# Access Compliance Report

## Public Rights-of-Way

Intersection ID: 2598	Main Street: DRISCOLL_CT	Cross Street: LAGRANDE_DR	Location: NE
ADA ID: 5263CD91AAC1	Ramp Type: PerpDiag	Initial Pass/Fail: Fail	Overall Compliance: No
		Severity Score: 12.5

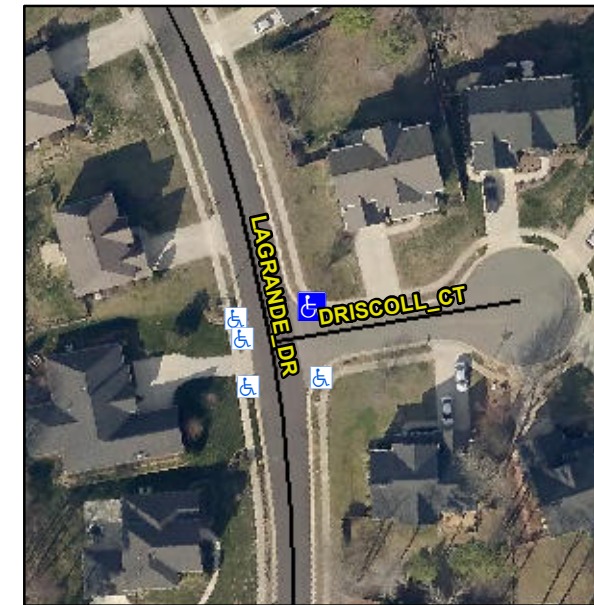
**Not Found, R304.5.3**

Compliance	Description	Data	Compliance	Description	Data
N/A	Ramp Length (in)	47.0	Yes	Ramp Slope (%)	5.5
Yes	Ramp Width (in)	58.0	No	Ramp XSlope (%)	6.5
N/A	Flare Type LT	N/A	N/A	Flare Type RT	N/A
N/A	Flare Slope LT (%)	N/A	N/A	Flare Slope RT (%)	N/A
N/A	Flare Traversable LT?	N/A	N/A	Flare Traversable RT?	N/A
N/A	Landing Length (in)	N/A	N/A	DWS Provided?	N/A
N/A	Landing Width (in)	N/A	N/A	DWS Contrast?	N/A
N/A	Landing Slope (%)	N/A	N/A	DWS Length (in)	N/A
N/A	Landing X Slope (%)	N/A	N/A	DWS Full Width?	N/A
N/A	Landing Curb? (Y/N)	N/A	N/A	DWS Offset (in)	N/A
N/A	Shared Landing?	N/A			
N/A	Gutter Ponding?	N/A	N/A	Gutter Slope (%)	N/A
N/A	Gutter Lip Ht (in)	N/A	N/A	Gutter X Slope (%)	N/A
N/A	Painted X Walk1?	No	N/A	Painted X Walk2?	No
	X Walk 1 Direction	To W		X Walk 2 Direction	To S
N/A	X Walk 1 Width (in)	N/A	N/A	X Walk 2 Width (in)	N/A
	X Walk 1 Slope (%)	4.4		X Walk 2 Slope (%)	0.4
	X Walk 1 X Slope (%)	3.6		X Walk 2 X Slope (%)	6.1

**Remove & Replace Curb Ramp With Two New Directional Ramps or Equivalent.**
